A UML model for link aggregation management

Mick Seaman

This note is an initial proposal for a UML model for managing link aggregation (LAG), developed as part of reviewing IEEE P802.1AX-Rev/D1.0.¹ While YANG is an obvious target, I hope changes suggested in this note can also be used to simplify the DRNI description and the revised MIB.

Figure 2—Link Aggregation management (draft)

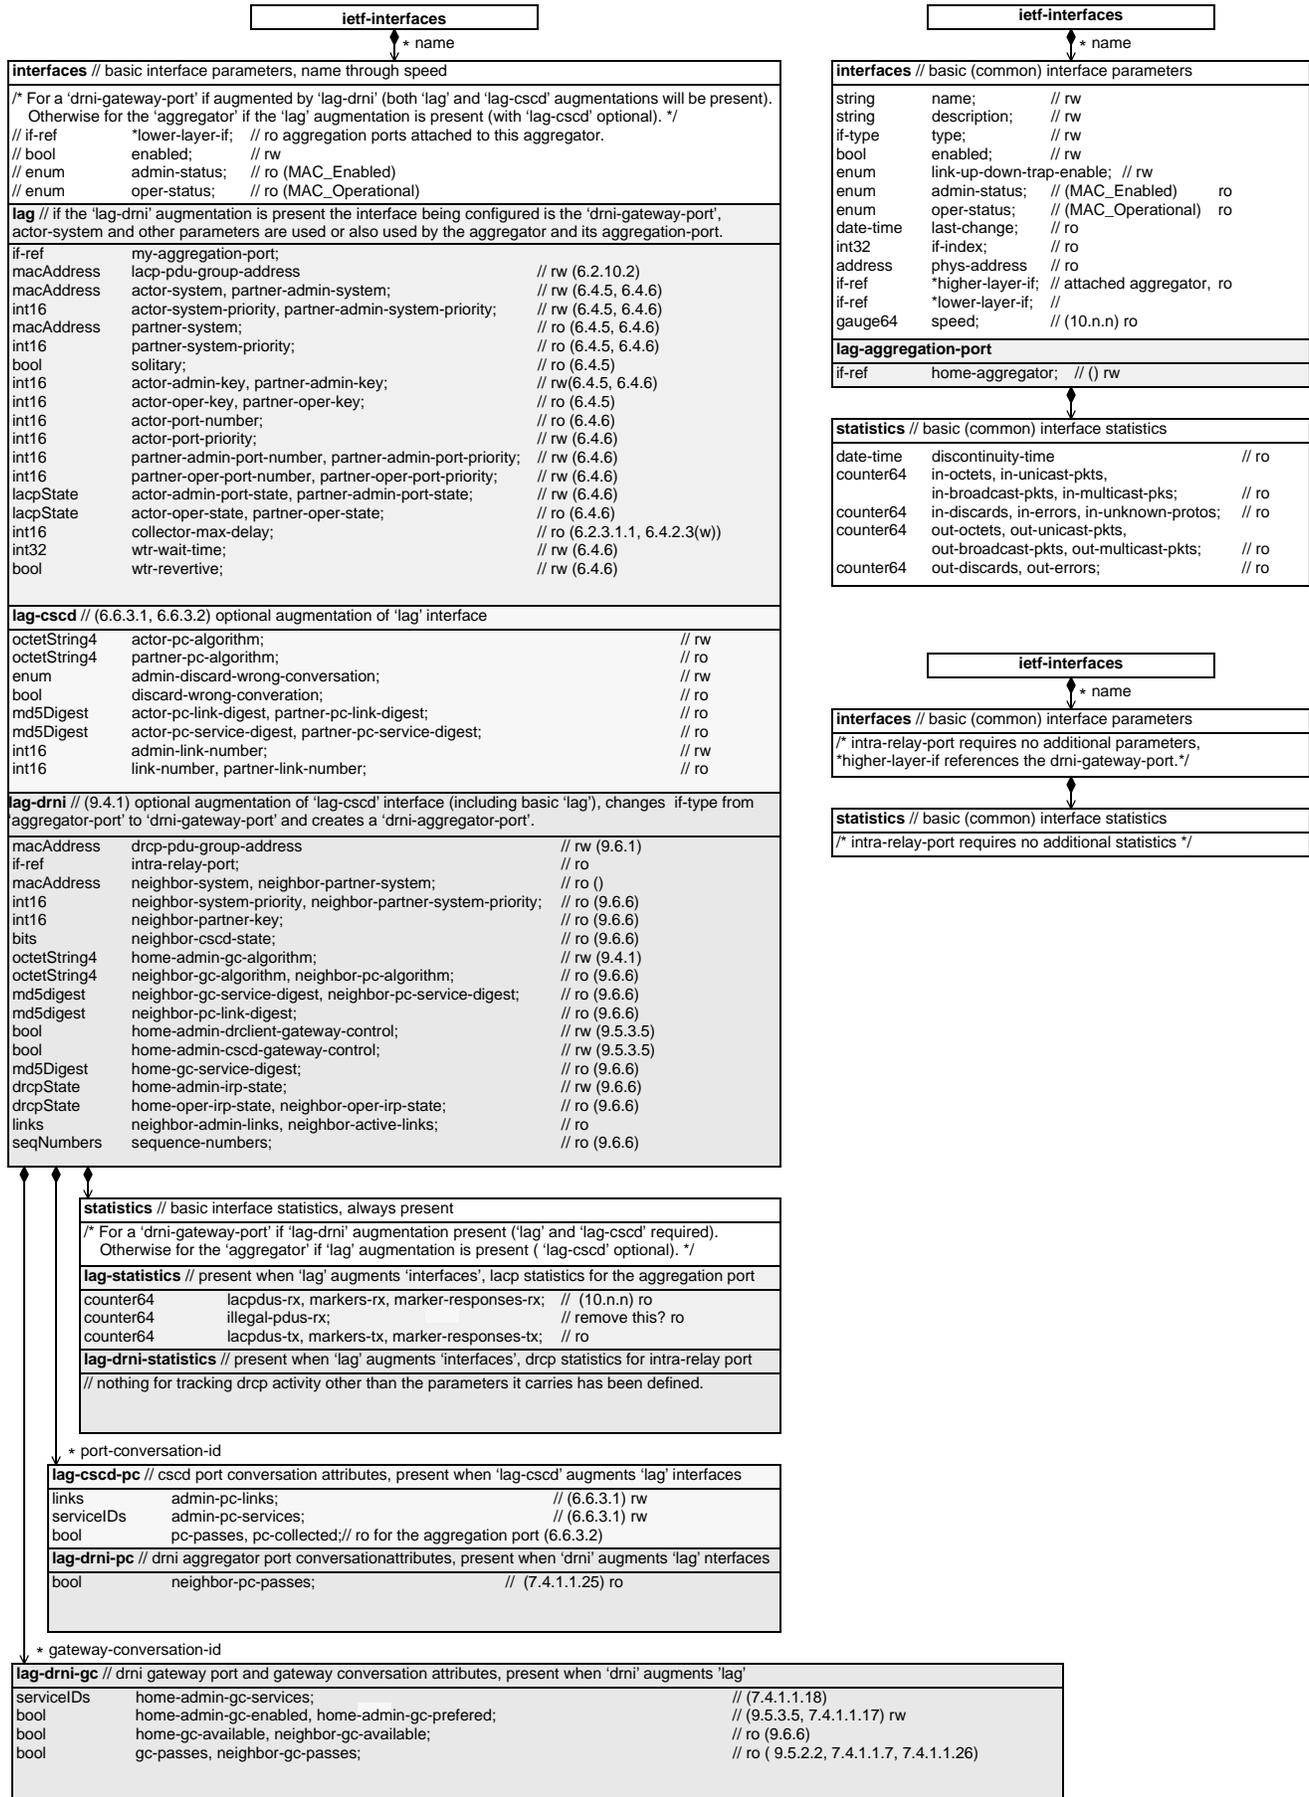
Basic LAG attributes are specified, with few exceptions, in IAX clauses 6.4.5 (aggregator variables) and 6.4.6 (aggregation port variables). Some have obvious mappings to **interfaces** attributes, e.g:

I have chosen names for **lag** attributes that should make their mapping to the individual variables in 6.4 obvious (changes include removing case-stopping and substituting hyphens instead of underscores, to align with general YANG conventions, and in some cases abbreviation where that does not introduce ambiguity). Some have (for the reasons detailed above) counterparts in both 6.4.5 and 6.4.6 and sometimes but not always the names of these counterparts can differ slightly, e.g. Actor_System (6.4.5) and Actor_Port_System (6.4.6). These differences are unimportant as the distinction between administrative and operational values remains clear.

Conversation-sensitive collection and distribution capability is managed by the **lag-cscd** augmentation, with attributes matching variables defined in 6.6.3.1 (per aggregator) and/or 6.6.3.2 (per aggregation port). In most cases the correspondence is clear though I have tried to avoid very long names. After reviewing the way that these attribute names are also used with DRNI I have (in most cases) abbreviated 'port-conversation' to 'pc'¹⁷, even where D1.0 simply uses 'port' e.g. 'actor-pc-algorithm' rather than 'actor-port-algorithm'. Other points include:

actor-pc-algorithm covers Actor_Port_Algorithm and Actor_Oper_Port_Algorithm. There is no need to manage the latter separately. If the aggregation port is not attached to an aggregator (its home aggregator cannot be enabled) it takes the special value "Unspecified", but there is no need to remind the administrator of that rule. The **lag-aggregation-port.higher-layer-if** provides the attachment status.

I think the D1.0 spec needs to change. Just acting on

the latest received on any link for these parameters implies ignoring the packet loss that can follow partner misconfiguration. Better to record each received value in the 'home' interface for each aggregation port (making only these values visible to management is sufficient, I have omitted 'oper' from the UML names for brevity) and do not turn on DWC unless all these received values match on an aggregator's 'active' links, i.e. those for which the actor is collecting.

actor-conversation-link-digest covers both **Actor_Conv_Link_Digest** and **Actor_Oper_Conv_Link_Digest**. There is no need to manage the latter separately. If the aggregation port is not attached to an aggregator (its home aggregator cannot be enabled) it takes the special value 'Unspecified', but there is no need to remind the administrator of that rule.

The DRNI (Distributed Relay Network Interface) operation of one of a pair of DRNI Systems is managed by the **lag-dnri** augmentation. A given system can participate in more than one pairing—though not with the same neighbour—supporting a single, separate, DRNI gateway port in each DRNI system for each pair.¹⁹ This makes it convenient to associate all the DRNI parameters with the gateway (port) interface. The gateway port also makes use of, or incorporates,²⁰ a single aggregator as previously described for LAG and CSCD management so can be created as an augmentation of that aggregator (port).

There is (I believe) no need for the 9.4.1 DRNI System Identifier²², or the Distributed Relay Number. The Actor System Identifier is sufficient, with the higher priority of the paired DRNI Systems taking the role associated with Distributed Relay Number if necessary. When the intra-relay connection (IRC) is operable, the Aggregation Ports that could be aggregated to support the gateway port (i.e. all those with a key value matching that of the gateway port) all use this higher priority Actor System Identifier in the LACPDUs they transmit. If the IRC fails, the lower priority system reverts to using its own Actor System Identifier, thus ensuring that its partner is not misled into believing that links to the now separated DRNI Systems can be aggregated.²³

home-admin-drclient-gateway-control matches 'network gateway control' (in AX-Rev/D1.0). The standard mentions the possibility of various types of DR Client, so the name for this control should not limit it to network protocols²⁴.

...lag-drni-gc.gc-enabled rather than ..lag-drni-gc.gc-enable to match the use of 'enabled' as a read-write control in the basic interfaces parameters. *I am unclear about the relationship between this variable and the gateway 'available' result.*
